15557-TUL-XX-XX-RP-C-91002 Issue 01

Land East of Longwater Road, Finchampstead, Longwater Road, Wokingham, RG40 3TS.

Discharge of Condition Consultation (Application Number 260289)

Planning Response for Conditions 7, 9 & 11.

GUI00X-TUL-XX-XX-DR-C-95-630

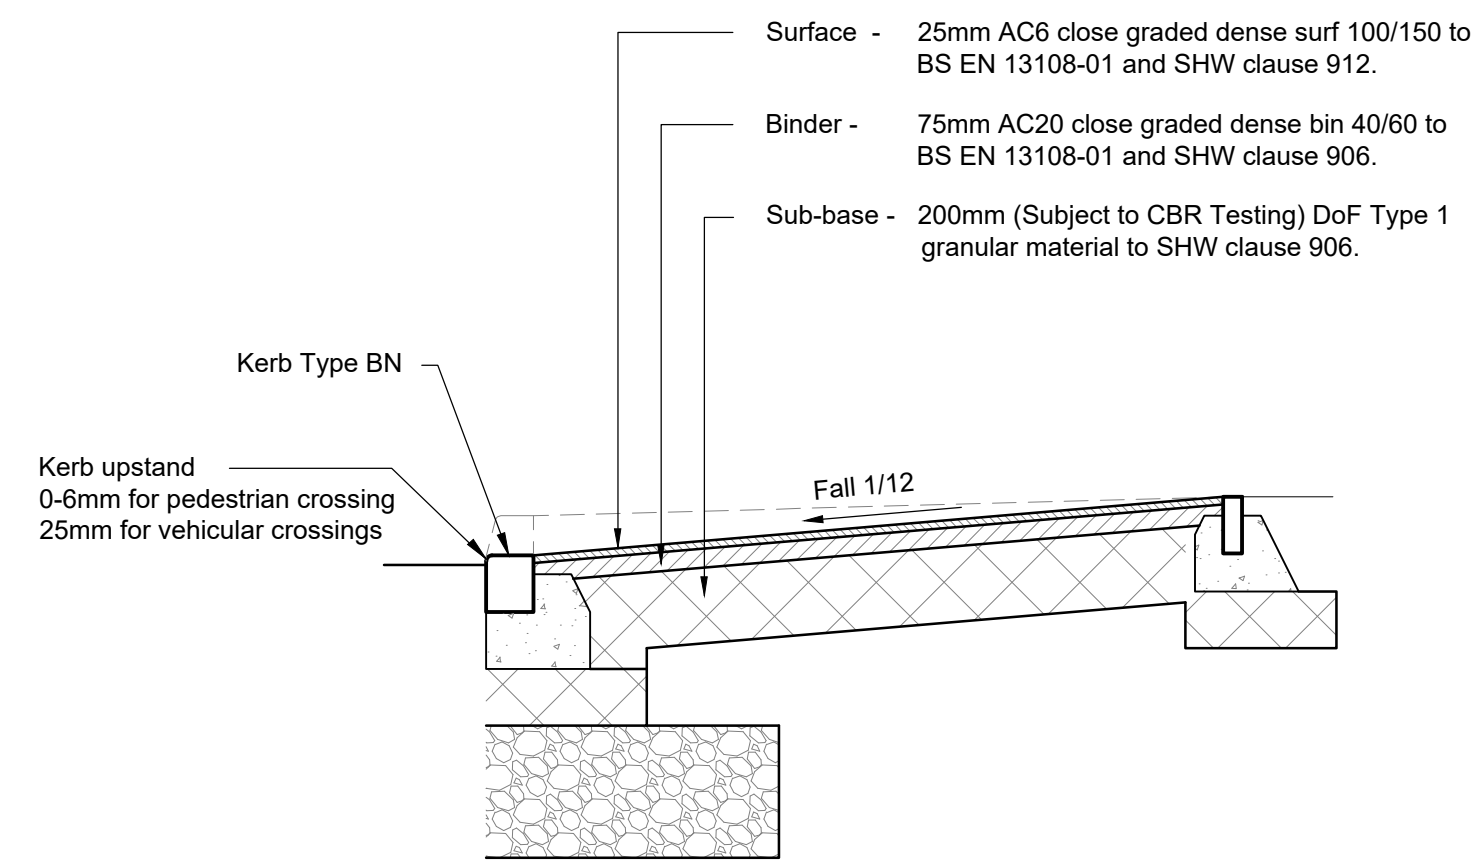
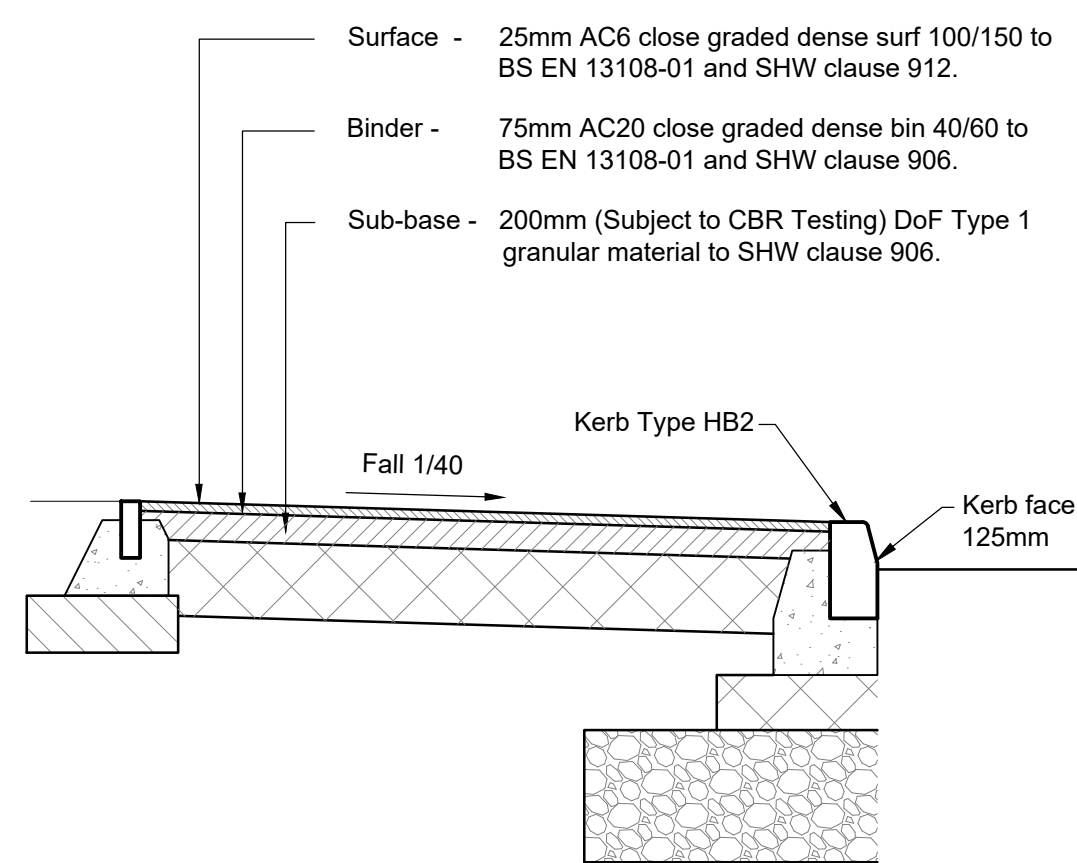
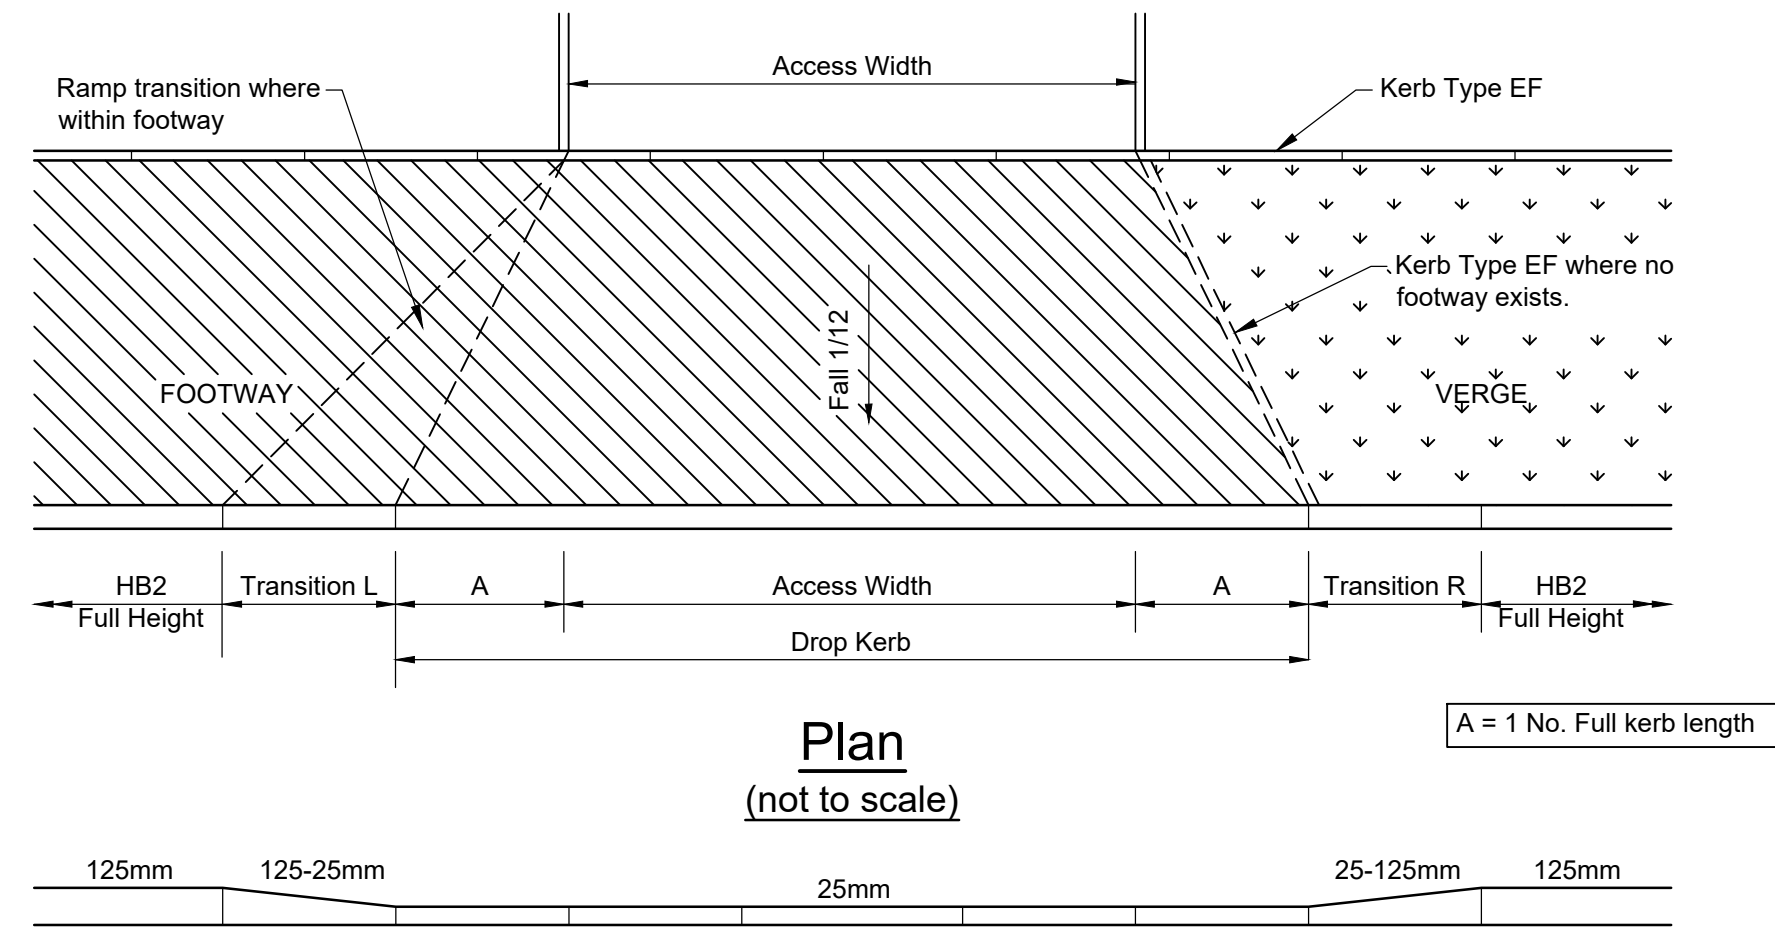
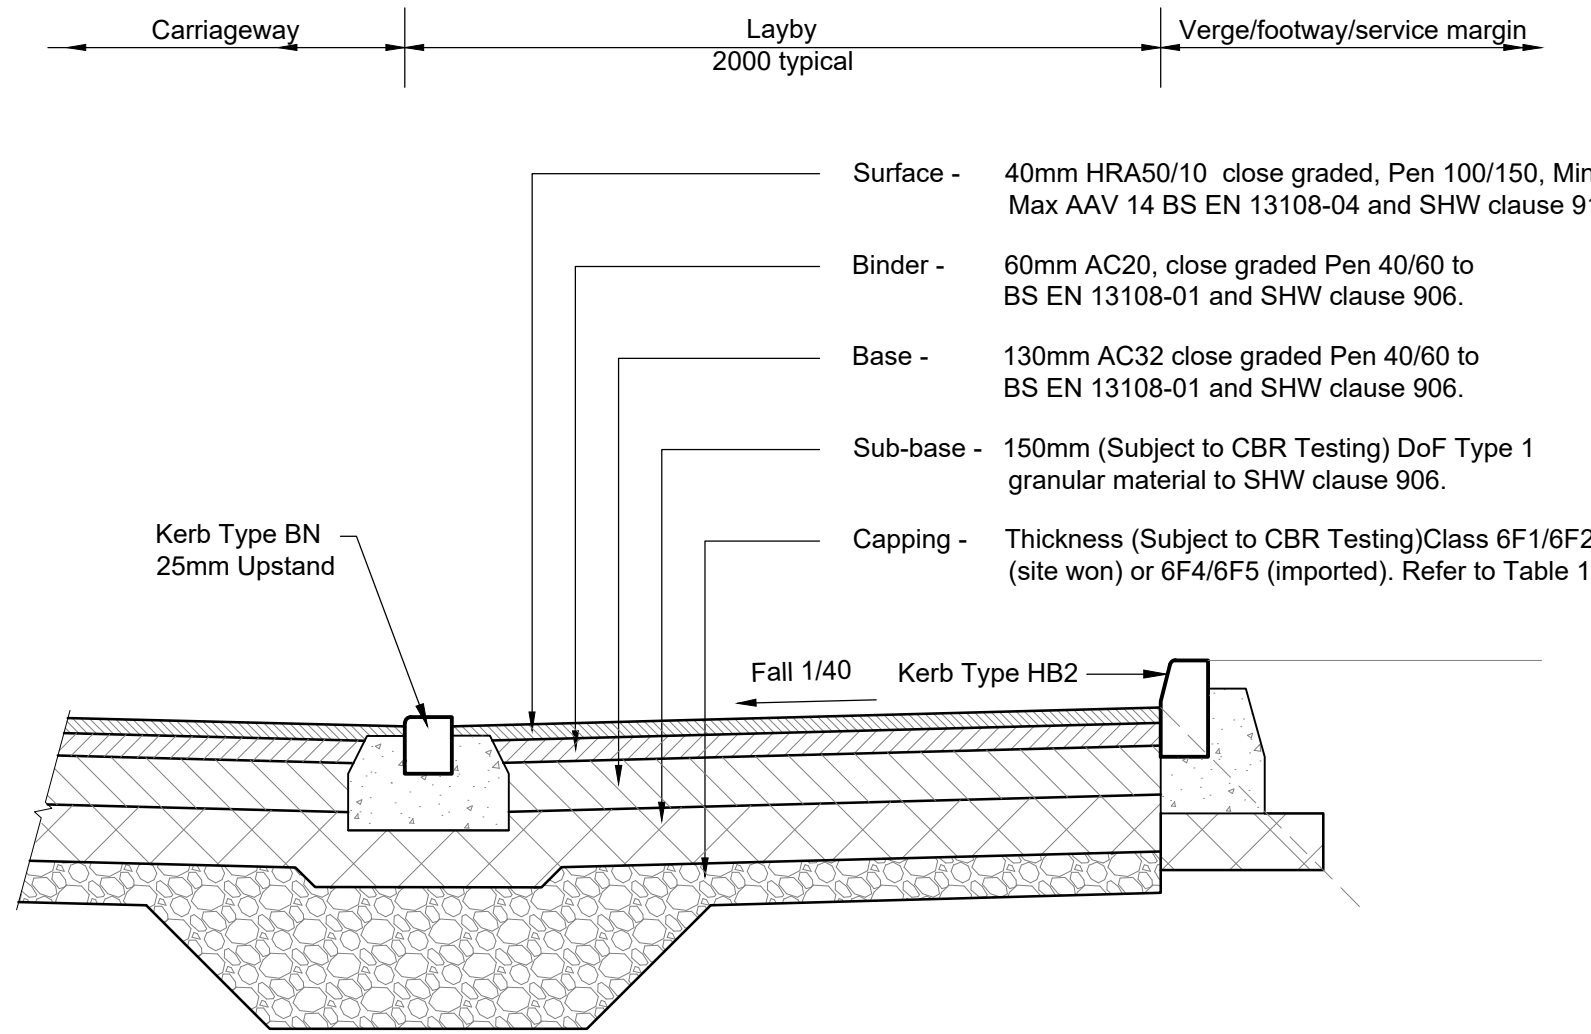
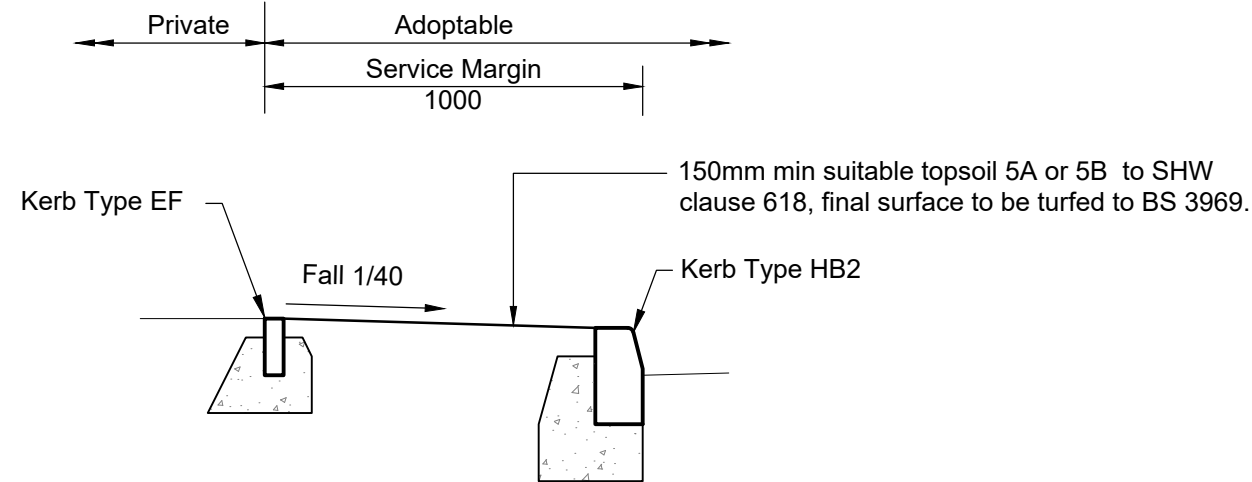
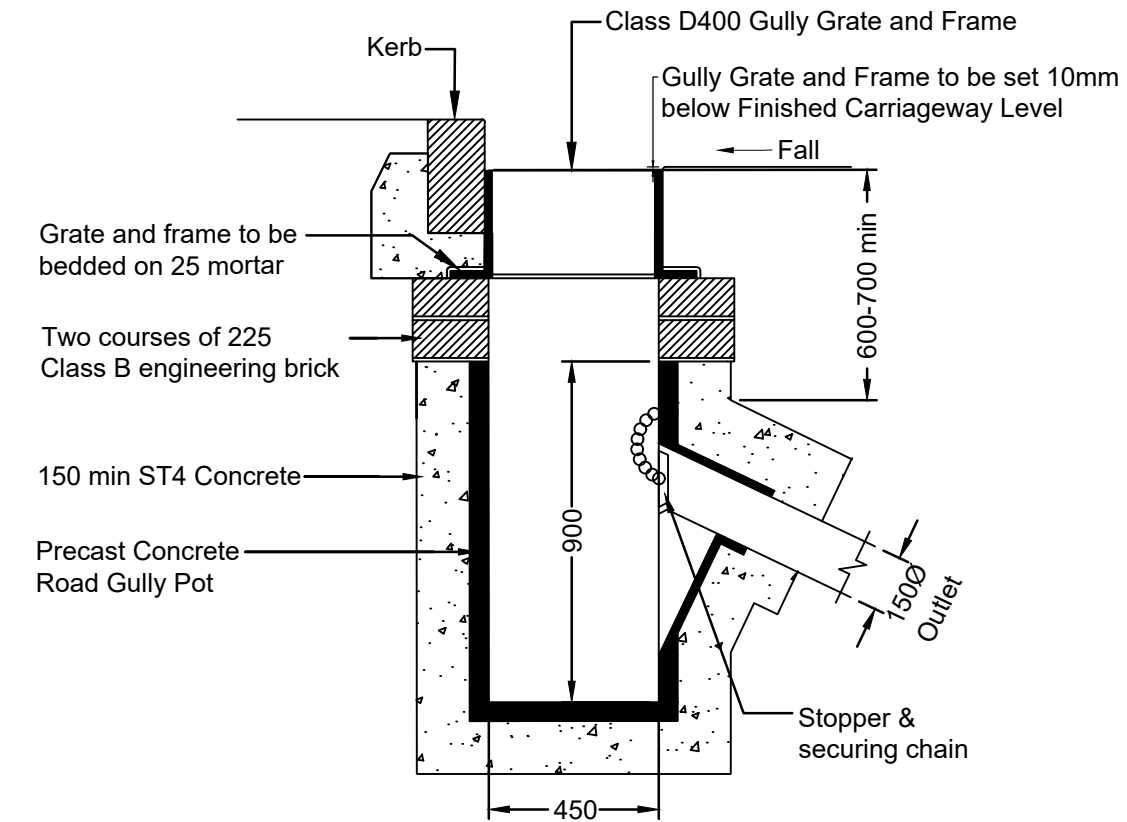
- *Forward visibility cannot be checked at bends without the submission of swept path analysis.*
- *Haunching needs to extend past the edging.*
- *All conduits to be SD4 instead of SD2.*

- *HRA50/10 required instead of AC10 (Surface course).*
- *Lighting drawings are required in order to allow comments to be made on the lighting strategy.*

- Haunching extended.

Refer to drawing GUI003-TUL-XX-00-DR-C-95-630_C02.

- ST4 mix updated.

Refer to drawing GUI003-TUL-XX-00-DR-C-95-630_C02.

- HRA50/10 added in lieu of AC10.

Refer to drawing GUI003-TUL-XX-00-DR-C-95-630_C02.

GUI003-TUL-XX-00-DR-C-95-800

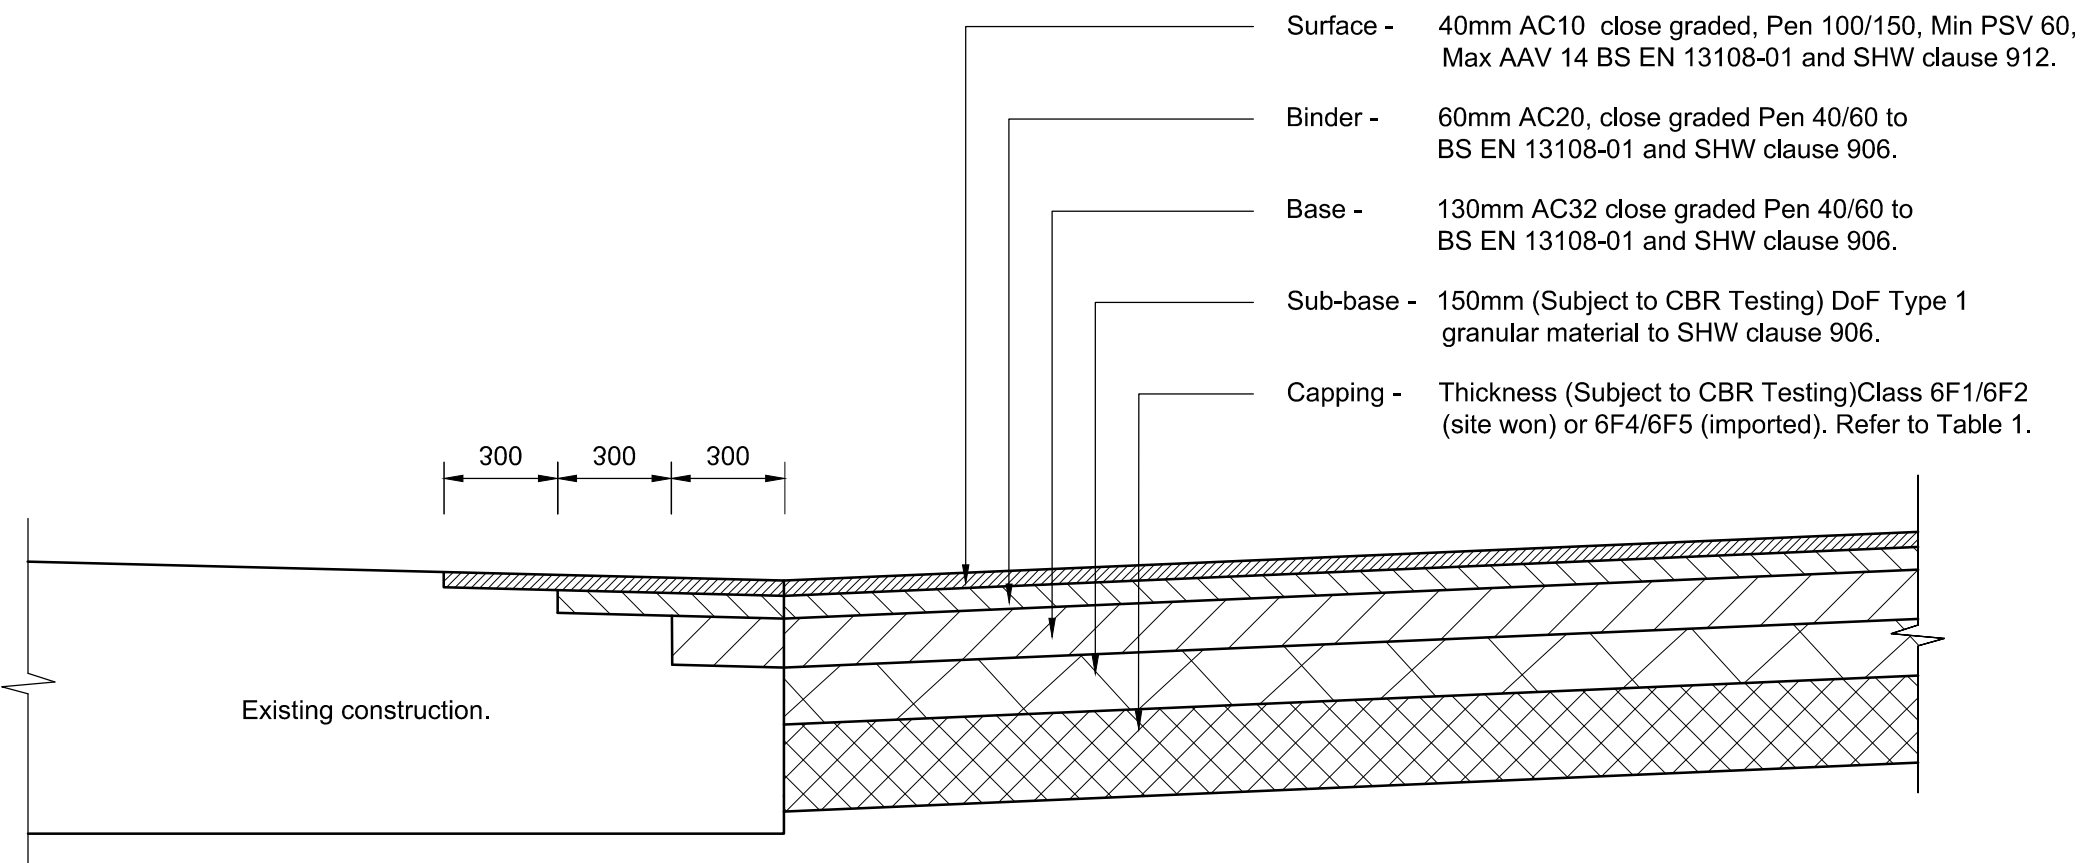
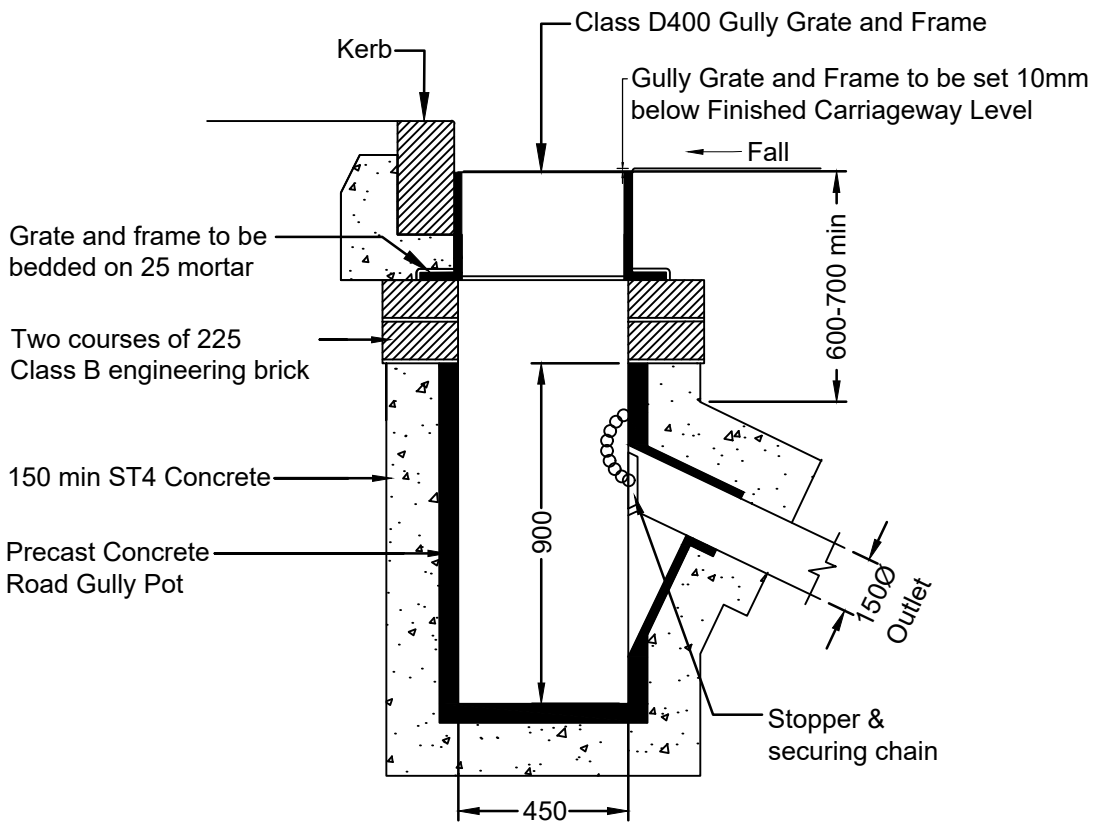
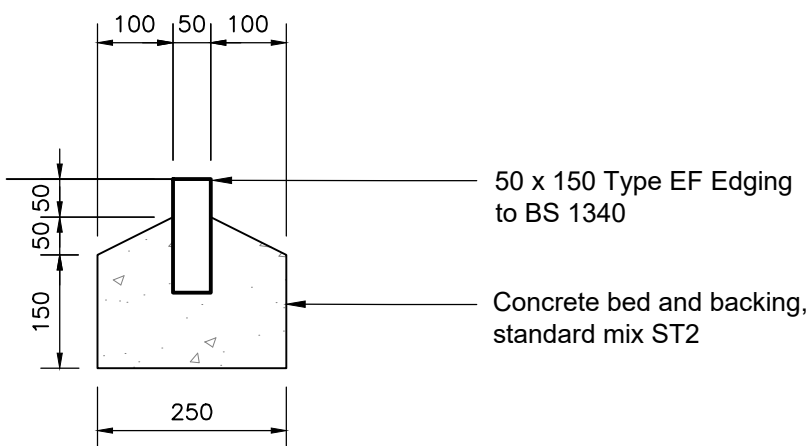
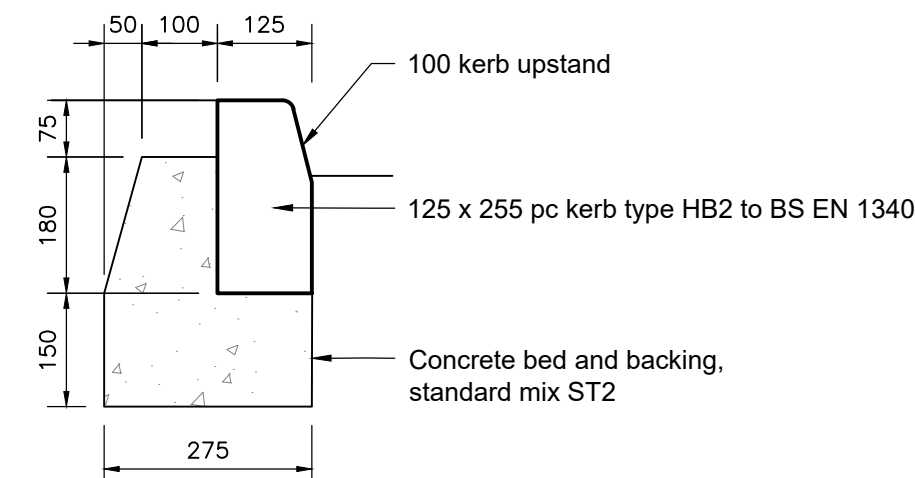
Prior to commencement of the development, there shall be submitted to and approved in writing by the local planning authority, details of the proposed vehicular access on to Longwater Road to include visibility splays of 43m x 2.4m. The access shall be formed as so approved, and the visibility splays shall be cleared of any obstruction exceeding 0.6 metres in height prior to the occupation of the development. The access shall be retained in accordance with the approved details and used for no other purpose and the land within the visibility splays shall be maintained clear of any visual obstruction exceeding 0.6 metres in height at all times. The applicant has provided GUI003-TUL-XX-00-DR-C-95-800_Section 278 - Longwater Road_P01 to address this condition. The plan provides detail on the access, but it does not appear to indicate visibility splays of 43m x 2.4m, as requested

Visibility splays shown on drawing GUI003-TUL-XX-00-DR-C-95-800_P03
